MEMORANDUM

REVIEW TYPE: Preliminary & Site Plan Review
APPLYING FOR: Subdivision to create one lot for a total of 100,094 square feet of mixed use development (including 59,450 square feet of retail, 23,973 square feet of office, 2,730 square feet of restaurant, and 13 residential dwelling units) on 8.10 gross acres. Parking waiver of ten spaces.

PROJECT NAME: Ashton Meeting Place
CASE #: 120050060 (Preliminary) and 820060230 (Site)
REVIEW BASIS: Chapter 50, Montgomery County Subdivision Regulations
 Chapter 59, Montgomery County Zoning Ordinance

RECOMMENDATION: Denial of both the Preliminary Plan and the Site Plan

Detail of Site Plan Along MD 650

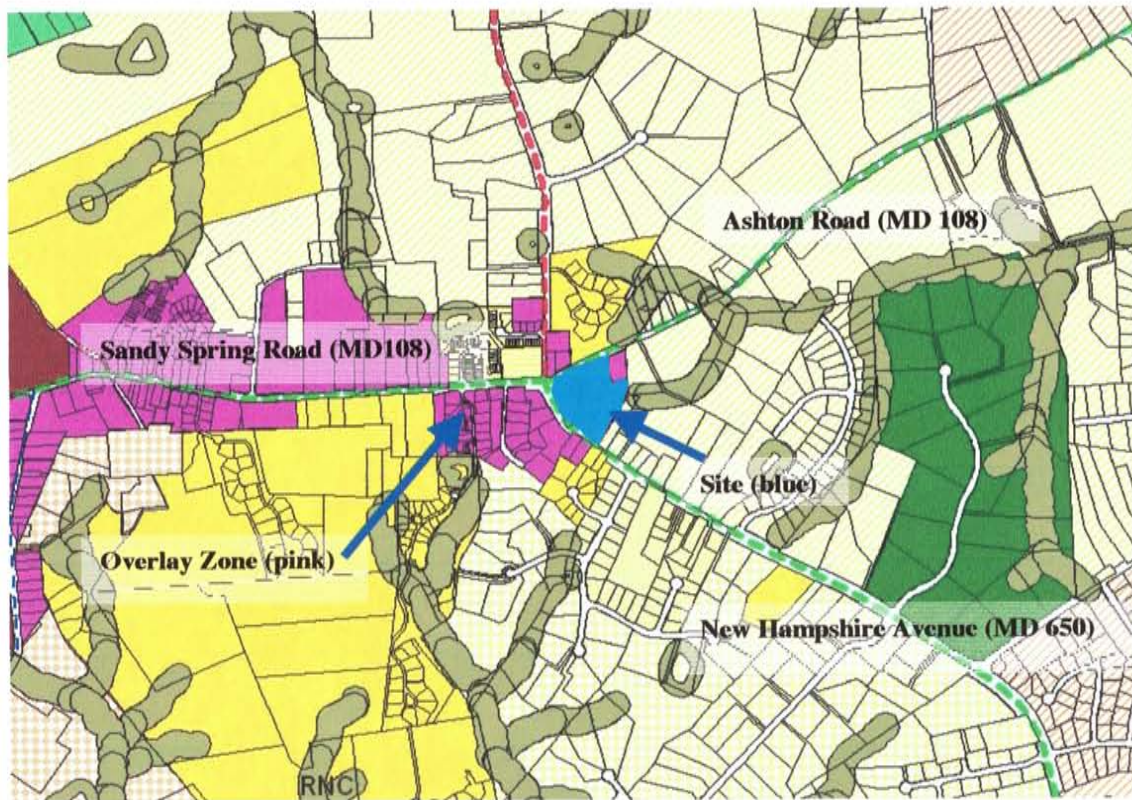
Along the MD 650 frontage there is a strip of retail, office, and restaurant space; this building is terminated by a community open space at its southern end. The 13 residential units will be located on the second and third floor of this structure. The building does not front directly on MD 650 - instead, a single loaded parking area with two-way traffic, a shrub border, grass strip, and sidewalk separate it from the road. The remainder of the surface parking is provided in the interior of the Property and is generally hidden from view from the adjacent roads. The plan also proposes 49 parking spaces in a subsurface structure under the retail/residential building along MD 650. This parking structure is to be used primarily by the residents of the 13 units and the owners or lessees of the retail stores but is open to the retail patrons. Access to the underground parking is immediately to the south of the restaurant.

The locations of the buildings, structures, and pedestrian and vehicular circulation systems along MD 650 are neither safe nor efficient. The duplication of streetlights and pedestrian sidewalks as well as the single-loaded parking in front of the storefronts are an inefficient use of resources and space. This design unnecessarily adds to impermeable surface and decreases the main street “walkability” of the site. This is especially true on a site with related environmental constraints.

Staff recommends that the buildings be pulled up to the street to provide a more efficient and safe pedestrian and vehicular environment as well as a safer, more efficient and more adequate in terms of environmental and site context.

FIGURE 13

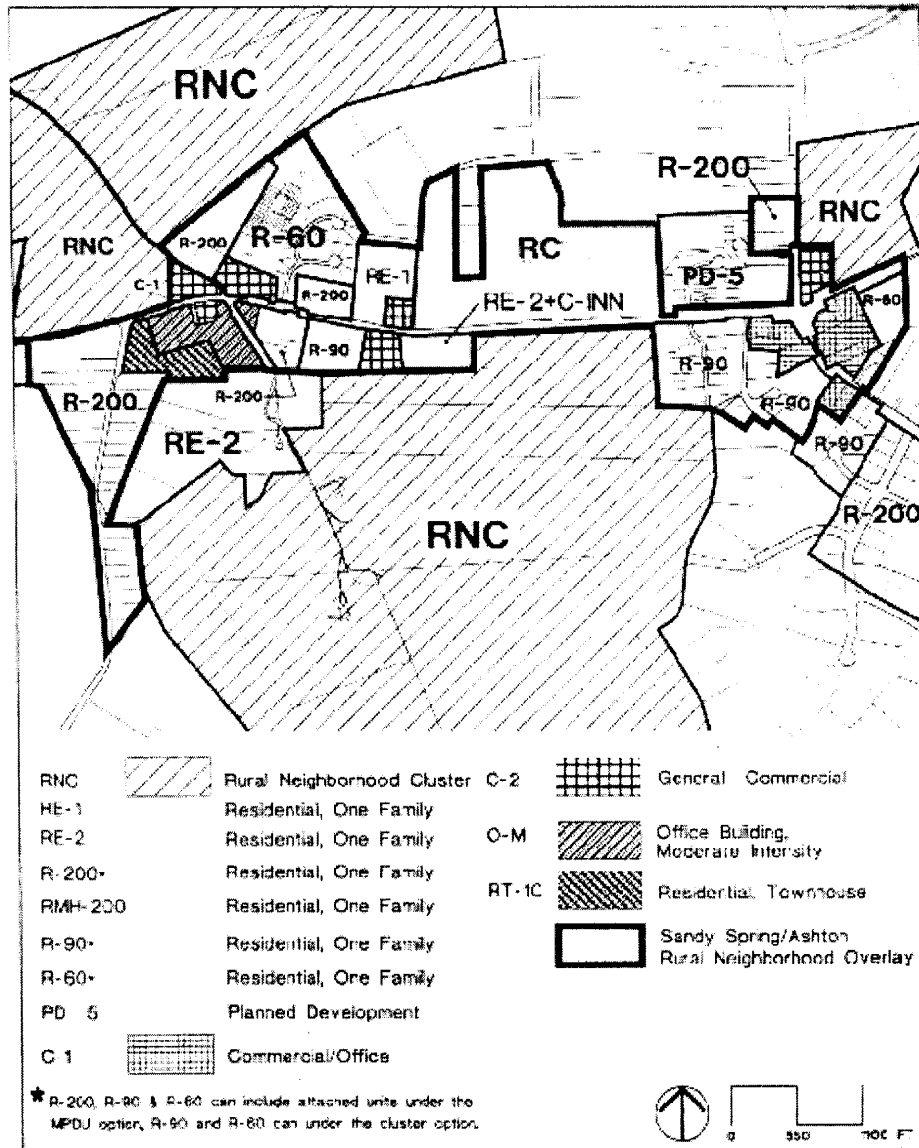
There is a more substantial problem with Zoning Ordinance section 59-C-18.184(b), which requires that any proposed development must “substantially conform with the design guidelines” in the master plan. In this case, there are several reasons why this finding cannot be made. There are several design guidelines specifically mentioned in the master plan:
